UNITED STATES PATENT AND TRADEMARK OFFICE

10/600,262

Office Action Summary	Application No.	Applicant(s)	
	10/600,262	LANNI, THOMAS W.	
	Examiner	Art Unit	
	Bao Q. Vu	2838

DETAILED ACTION***Claim Rejections - 35 USC § 103***

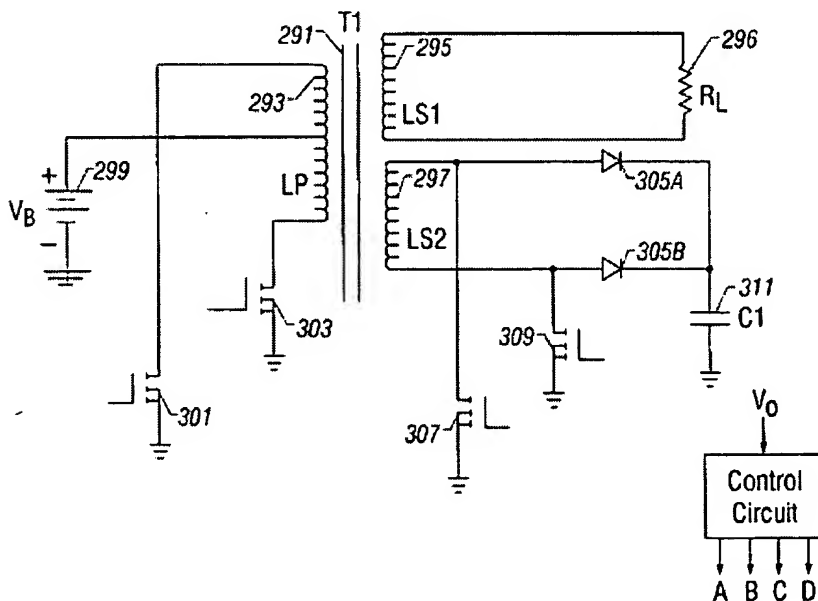
2. Claims 1, 2, 18, and 47 are rejected under 35 U.S.C. 103(a) as being unpatentable over Balogh (USP 5,946,202) in view of Steigerwald et al. (USP 5,119,283). Balogh discloses an input voltage system to receive AC power (see abstract), a transformer, T1, a boost circuit coupled to transformer wherein the secondary winding (LS1 and LS2) is configured as a boost inductor. The power converter is capable of receiving a DC input (299). See figure below.
